2. Atwood Homestead Estates; KPB File 2024-078
Johnson Surveying / Burger
Location: MP 122 Sterling Hwy & Camp Robber Ave
Clam Gulch Area

## ITEM #2 - PRELIMINARY PLAT ATWOOD HOMESTEAD ESTATES

KPB File No.	2024-078
Plat Committee Meeting:	August 12, 2024
Applicant / Owner:	Richard Burger / Clam Gulch, AK
Surveyor:	Jerry Johnson / Johnson Surveying
General Location:	Wise Owl Ave & Sterling Highway / Clam Gulch, AK

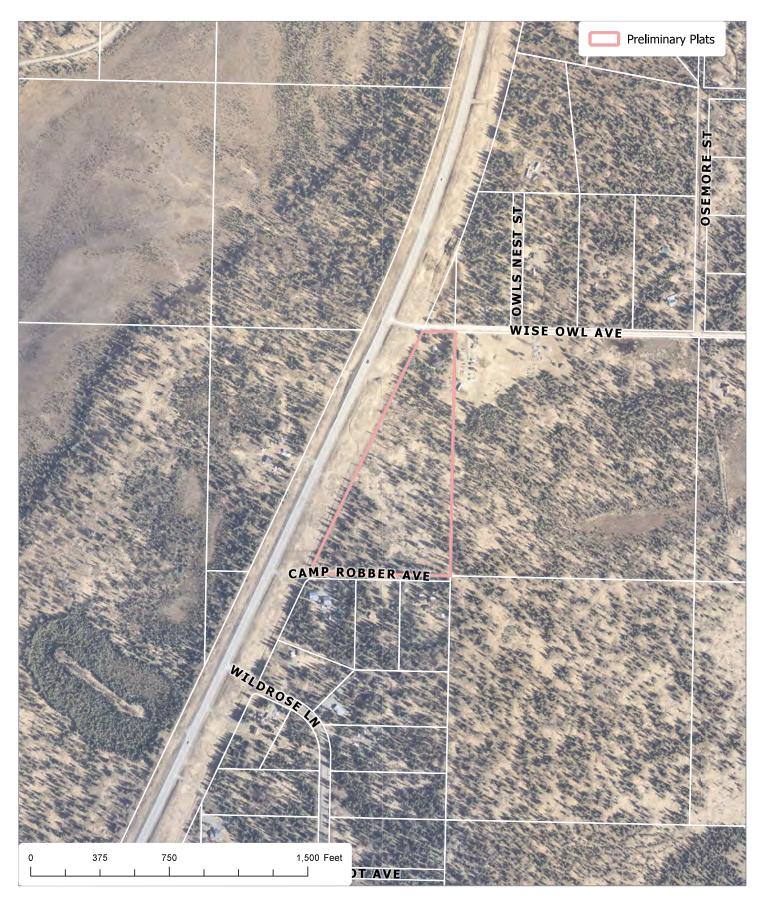
The plat lies east of the Sterling Highway. The state of Alaska DOT has commented that access to the two tracts shall be limited to Wise Owl Ave for Tract A and Camp Robber Ave for Tract B. Wise Owl Ave is a borough maintained road; this plat will be giving a 33' dedication to. No dedication is given on the north side of the road, but a 33' section line easement is in use on the north side. On the south side of the plat is Camp Robber Ave, an installed road with private maintenance. There is a 30' dedication from the south and this platting action is dedicating 30' for the north half of the road. The State of Alaska DOT has requested a plat note be added to the plat as follows: "No direct access to the Sterling Highway for Tract A and Tract B." **Staff recommends** the surveyor add the note as requested.

The plat is affected by a 33' section line easement on the north line of the plat. **Staff recommends** the surveyor reference the section line easement on the north line and continue it east.

There are no steep areas located on the site. There is a wetland crossing this plat that is not shown which is located on Tract A. The River Center review has not identified the plat to be in a FEMA designated flood hazard zone though. It is also not located in an habitat protection district. **Staff recommendation**: place a note on the final plat indicating any person developing the property is responsible for obtaining all required local, state, and federal permits, including a U.S. Army Corps of Engineers wetland determination if applicable.

Add a Plat Approval with the Date of August 12, 2024.

Add Certificate of Ownership and Dedication

Add Notary's Acknowledgement

Add Certificate of Acceptance tot eh Kenai Peninsula Borough for Wise Owl Ave and Cam Robber Ave In plat note #5 correct the word disclosed in line 2 and 1613 in line 4.

- Roads must meet the design and construction standards established by the borough in order to be considered for certification and inclusion in the road maintenance program (KPB 14.06).
- State of Alaska DOT note

Add KPB File NO 2024-078 to title block.
Change the section no in the legal description to 18
Correct the owner's name to Richard
